ADDENDUM NO. 2

TO: PLANS AND SPECIFICATIONS FOR STATE OF MISSOURI

Third Floor Renovations MoDOT Millbottom Building Jefferson City, Missouri PROJECT NO.: 02225-01

THIRD FLOOR FIRE ALARM PLAN

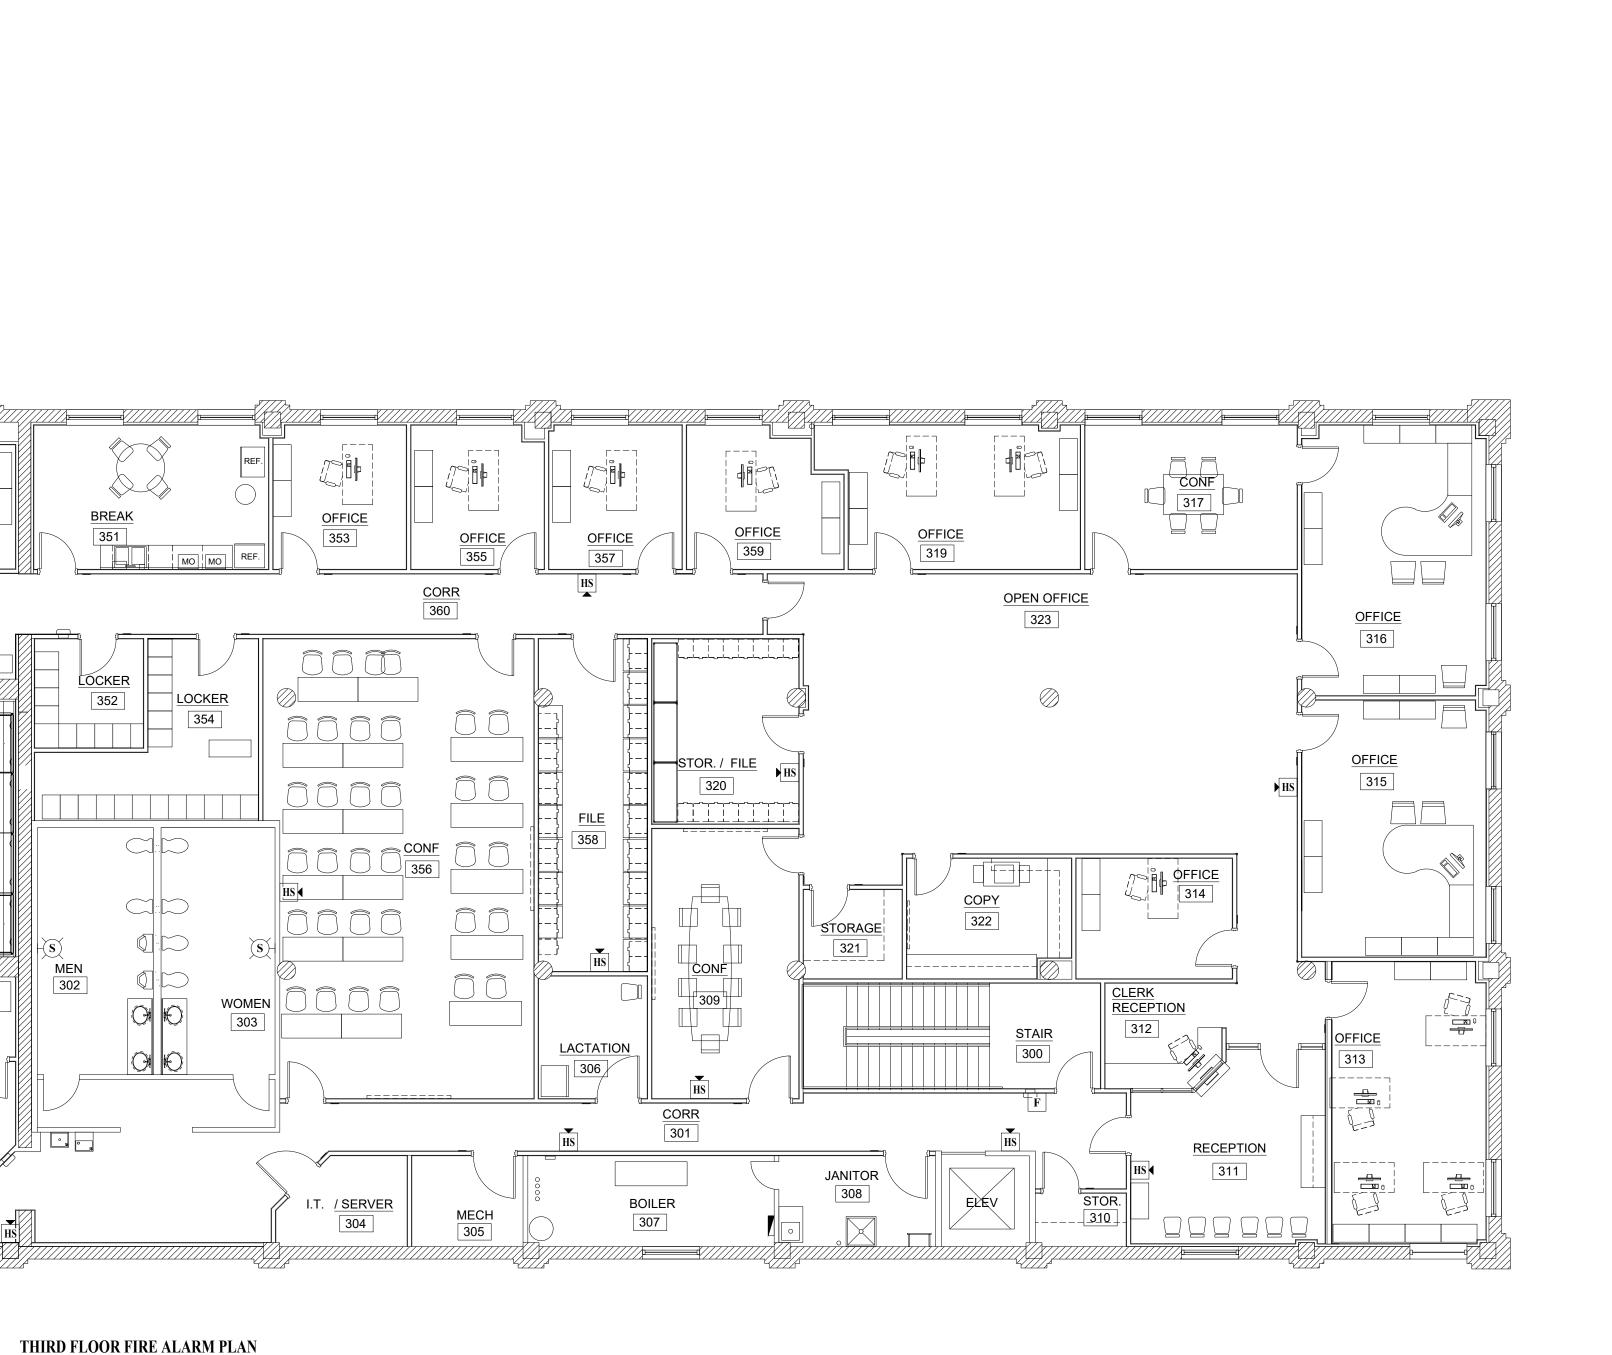
10. Sheet F101

a. REVISE Deferred Submittal Note No 1 as follows: Fire Alarm Contractor to provide deferred submittal for Fire Alarm system that will be tied into existing Edwards Fire Alarm system. Submittal to include battery calculation, voltage drop calculations, sealed engineered plans, and device cut sheets for devices & panels.

THIRD FLOOR WATER PLAN

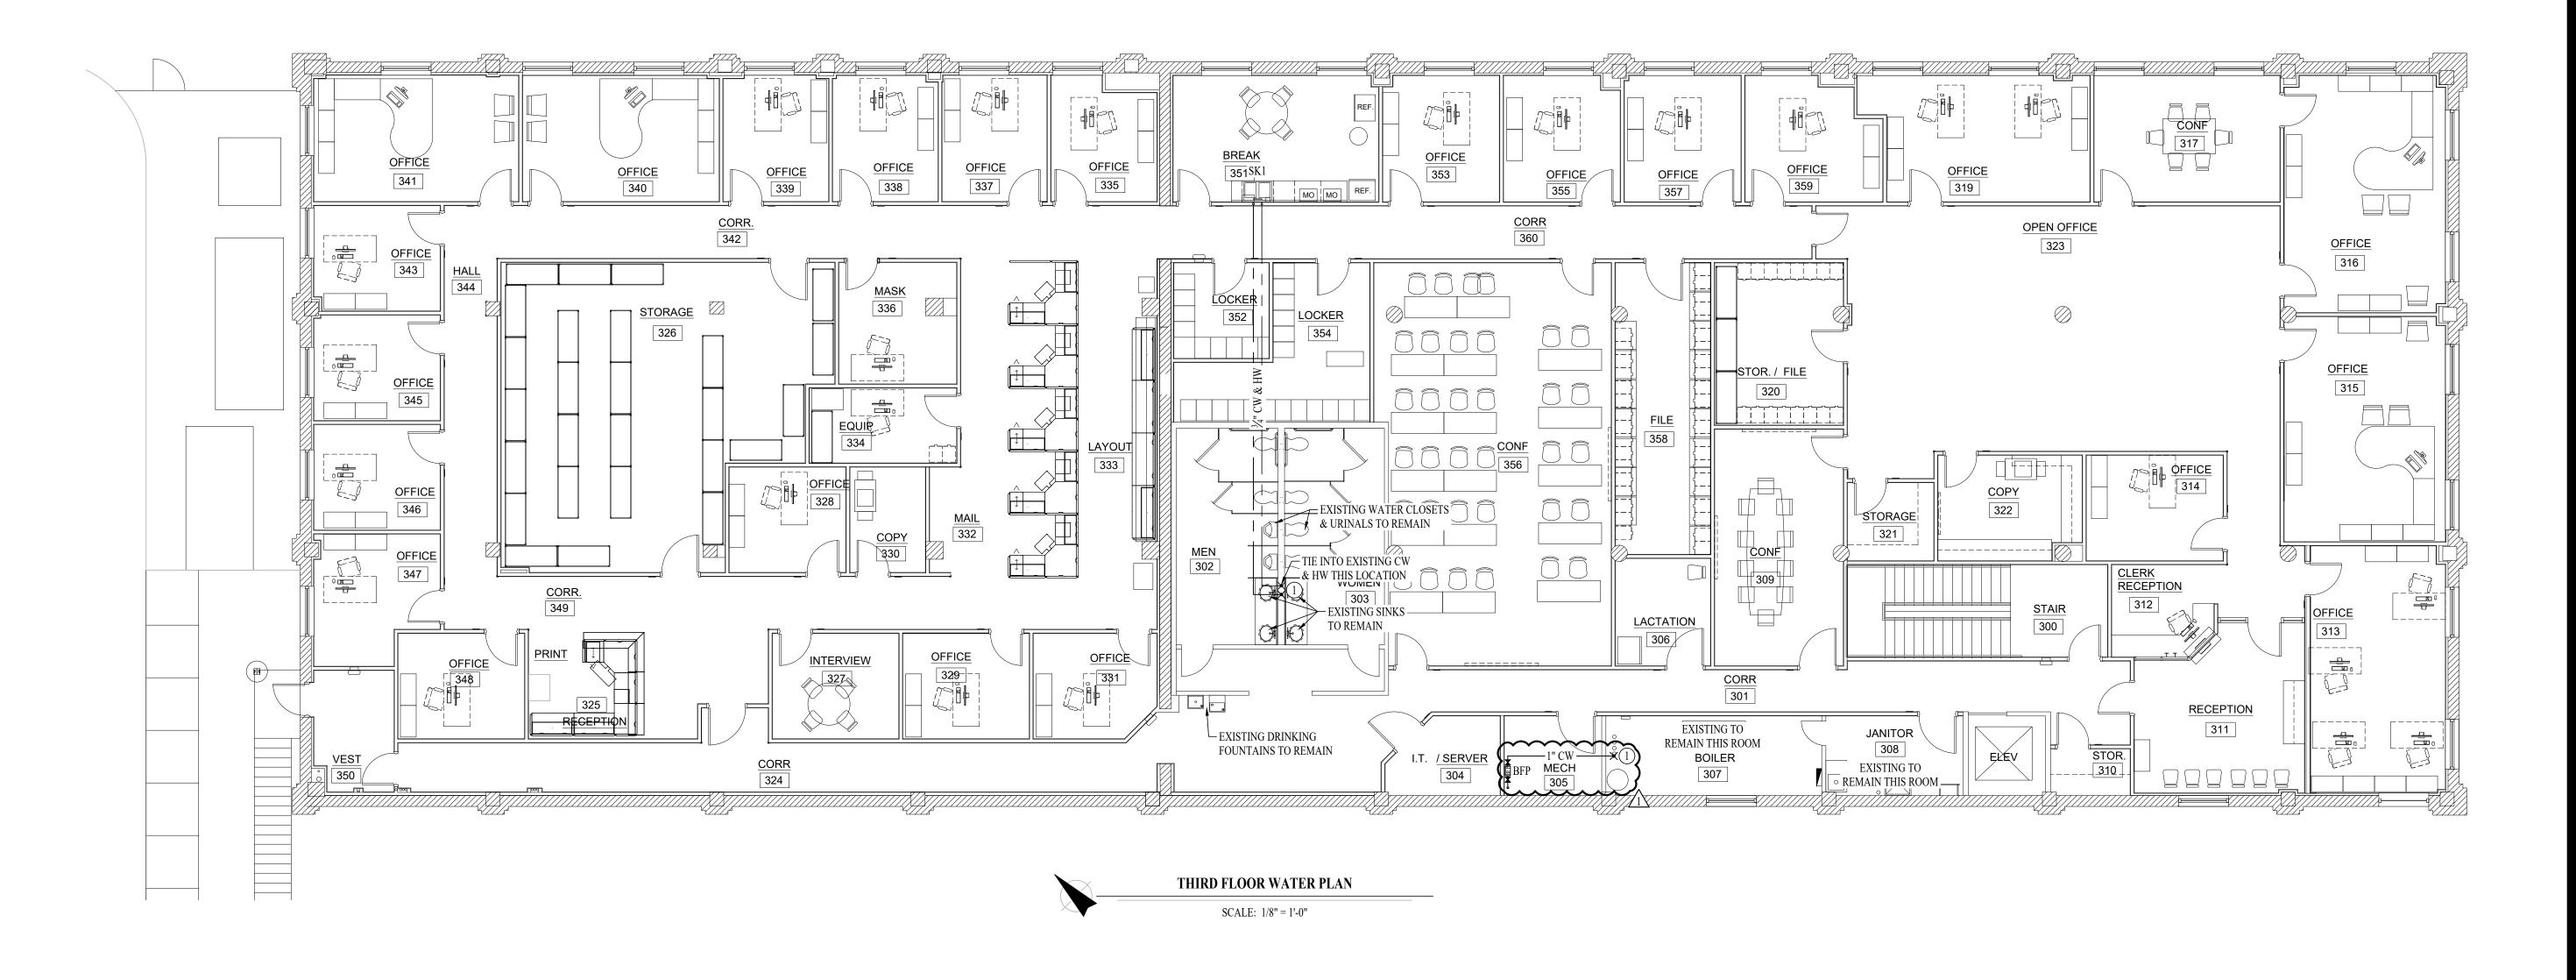
11. Sheet P102

- a. REVISE Room Name for Room 305
- b. ADD Water Line and Backflow Device at Room 305.

ROOFTOP GAS PLAN

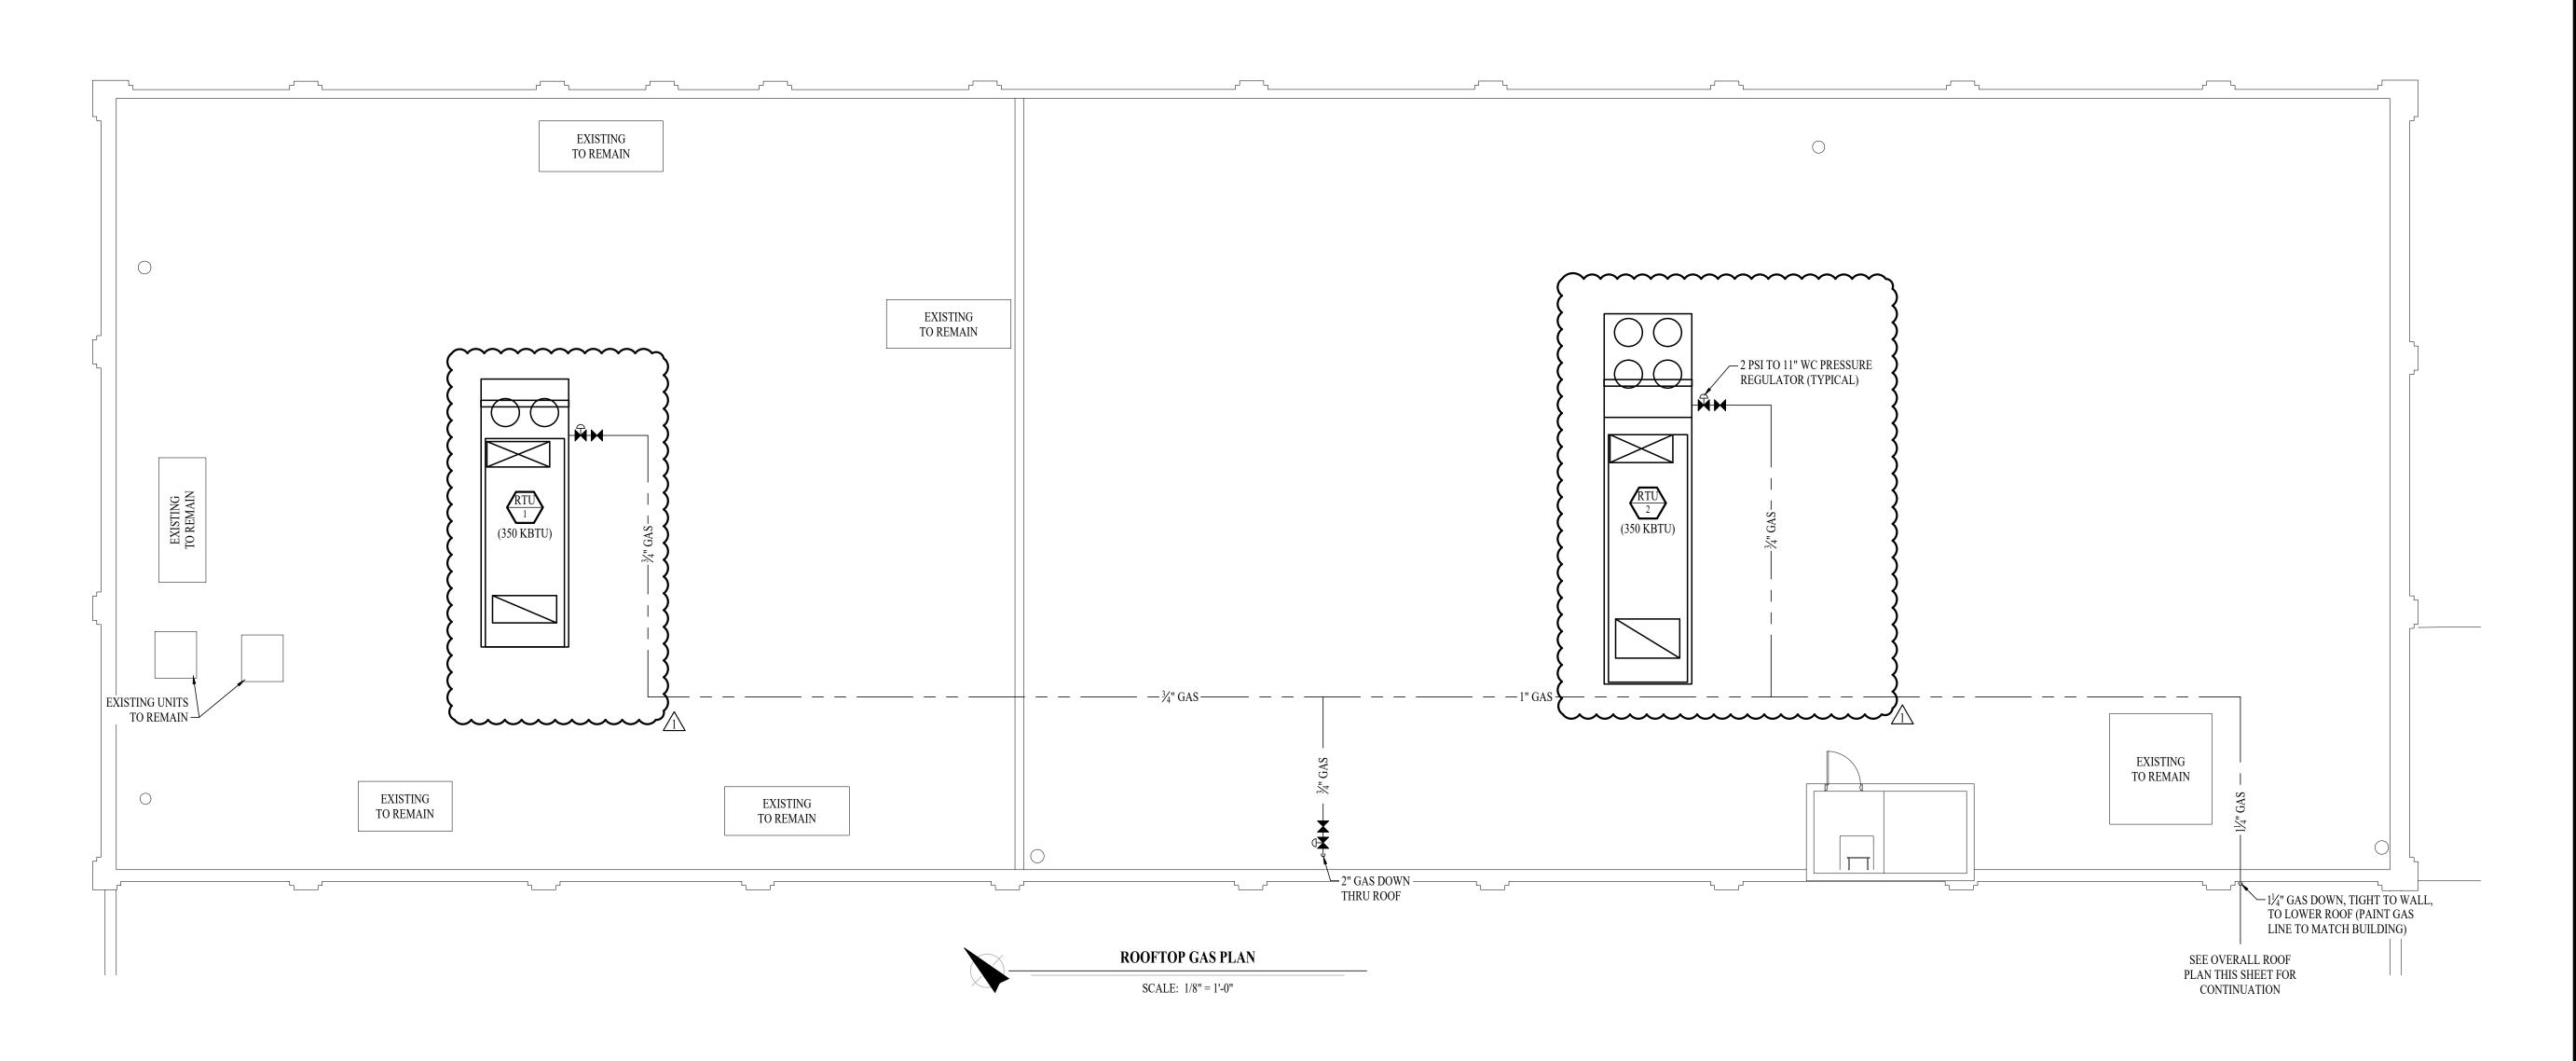
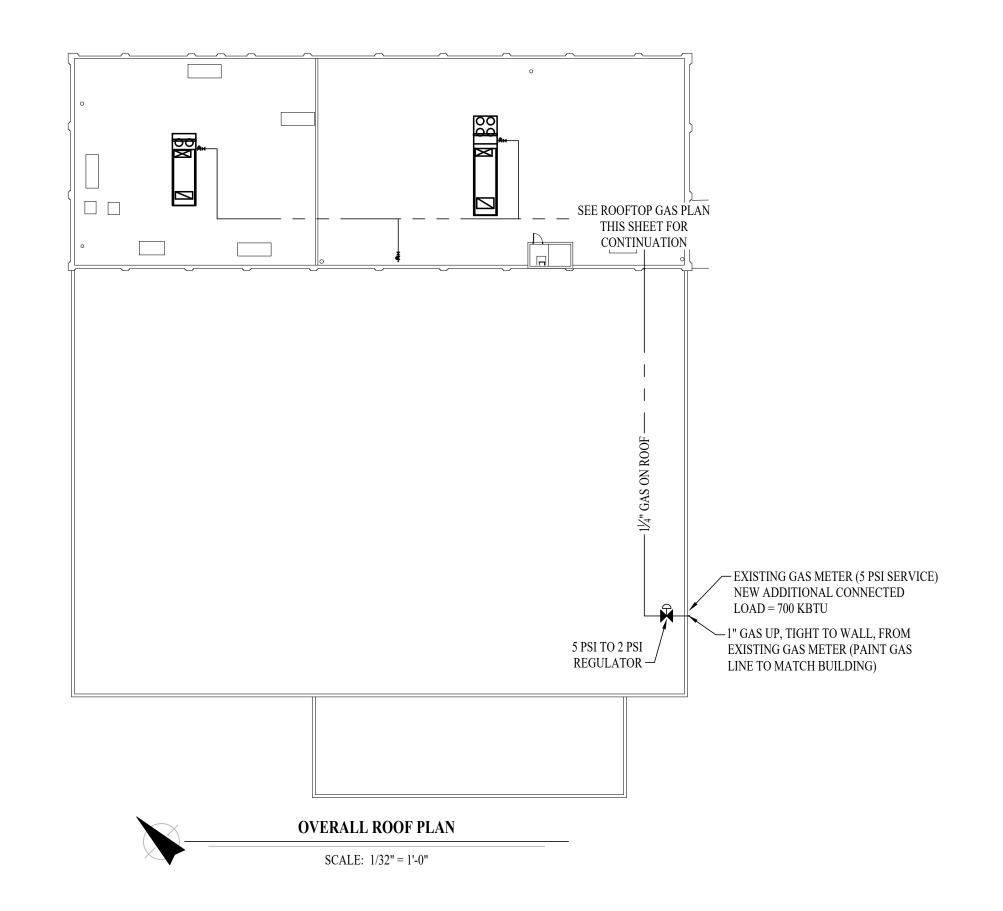
12. Sheet P103

- a. REVISE Rooftop gas plan unit layout.
- b. REMOVE HP-1 Note.
